## POWER DISTRIBUTION LIMITS

### 3/4.2.4 DNBR MARGIN

NPF-38-144

ATTACHMENT B

FIGURE 3.2-2

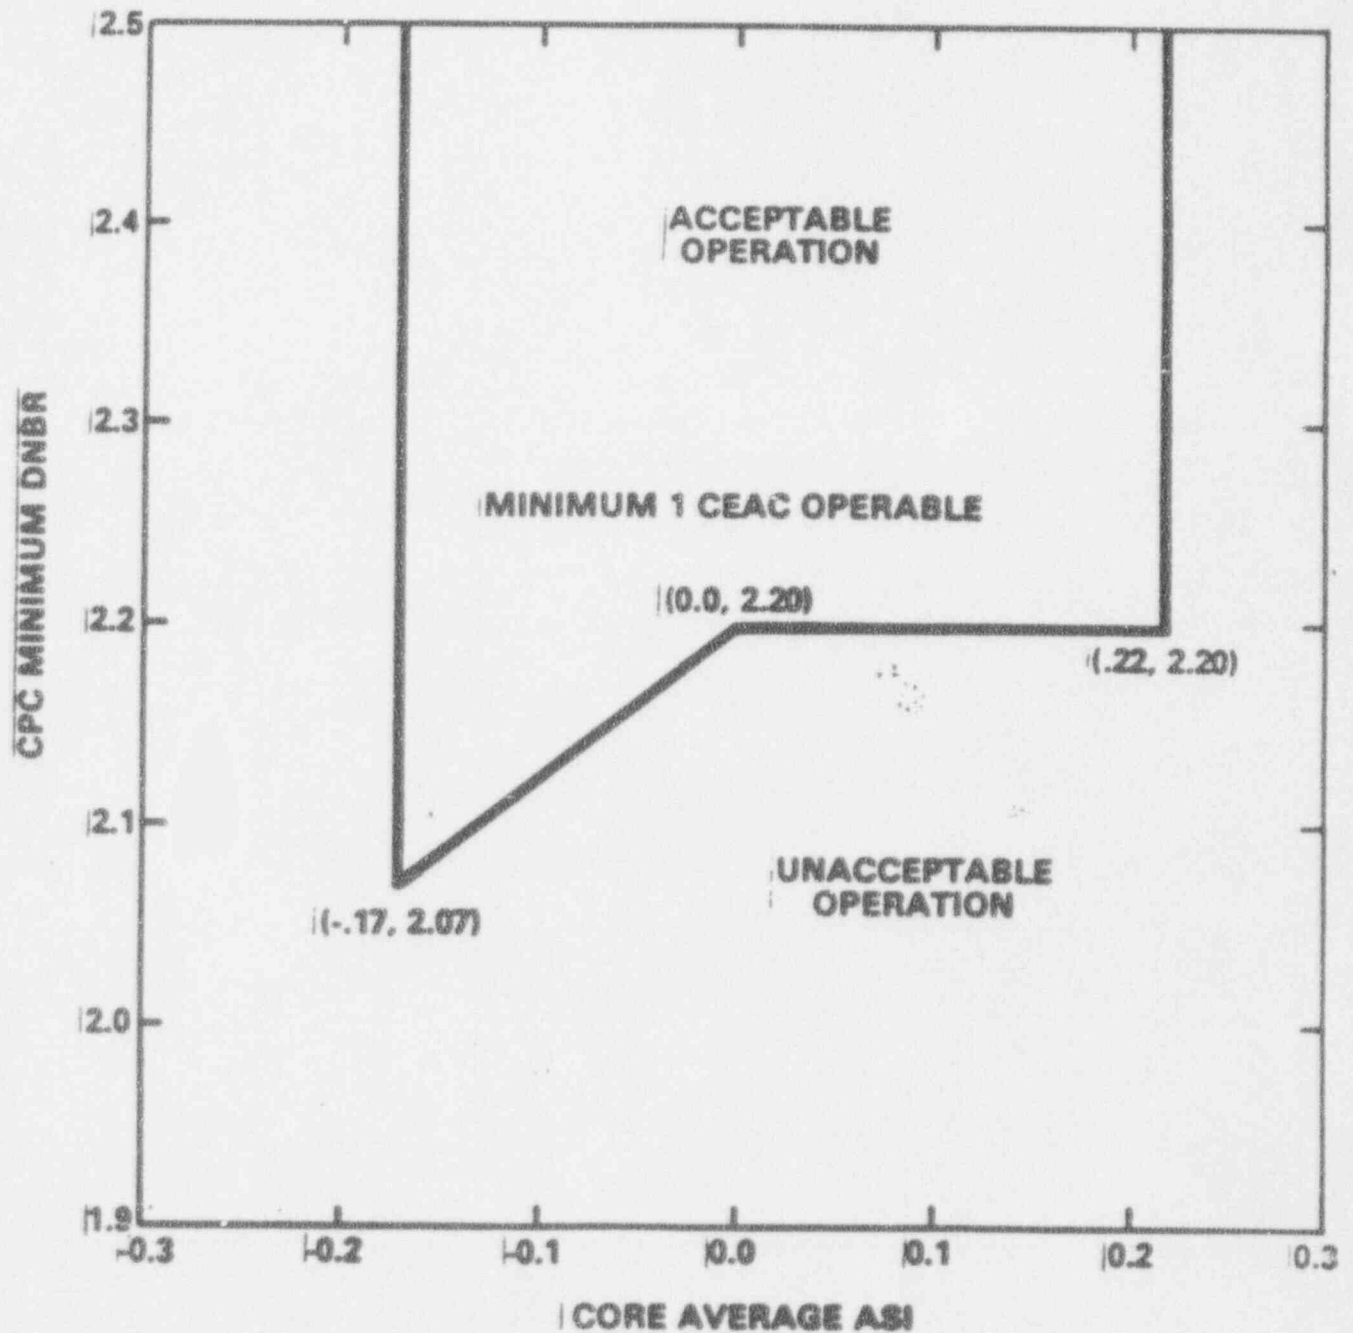
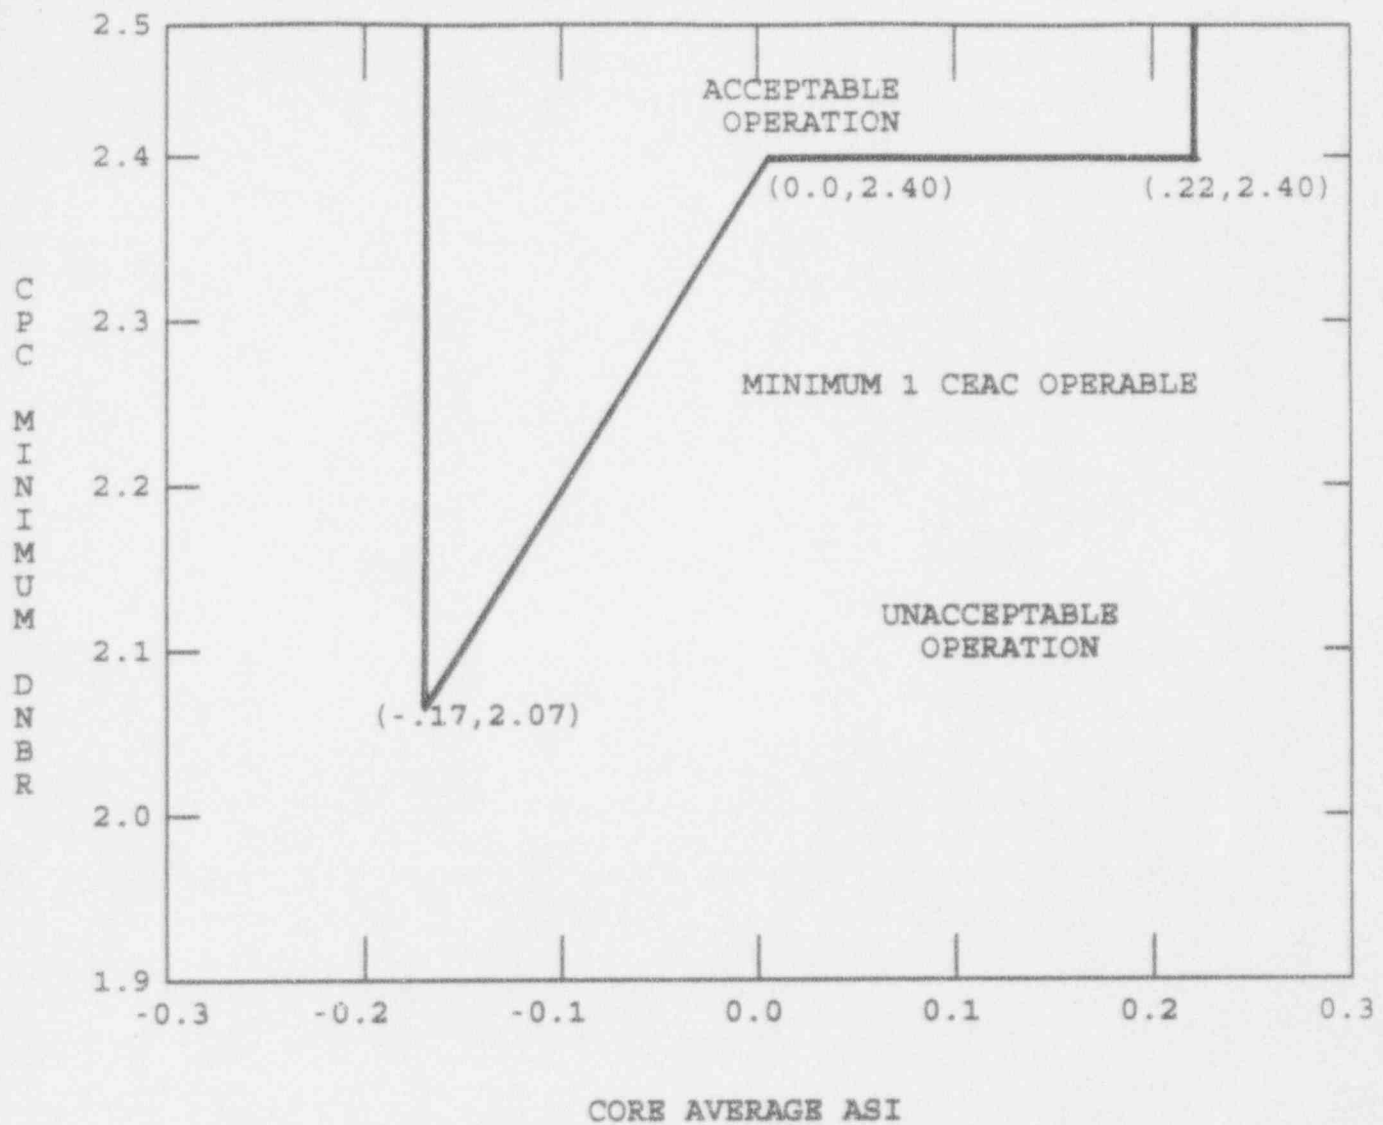
COLSS OUT OF SERVICE DNBR LIMIT LINE

DNBR MARGIN OPERATING LIMIT BASED ON CORE PROTECTION CALCULATORS  
(COLSS OUT OF SERVICE, CEACs OPERABLE)

# COLSS OUT OF SERVICE DNBR LIMIT LINE

DNBR MARGIN OPERATING LIMIT BASED ON CORE PROTECTION CALCULATORS  
(COLSS OUT OF SERVICE, CEACs OPERABLE)
